Amendments to the Drawings:

REMARKS

FIG. 2e

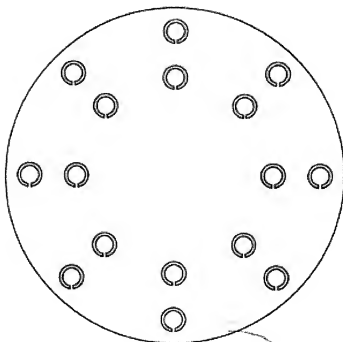
The attached sheet of drawings includes changes to FIG. 2. This sheet, which includes Figs. 2a-2e, replaces the original sheet including Figs. 2, 2a-d.

The Office Action brought to the Applicants' attention an inconsistency between the drawings and the Brief Description of the Drawings in the Specification.

The Applicants submit herewith an amended drawing sheet in which "FIG. 2" has been relabeled as "FIG. 2e".

The Applicants have also amended the specification at paragraph [0049] to properly indicate that FIG. 2e shows 8 pairs of slots for simultaneous fiber extrusion.
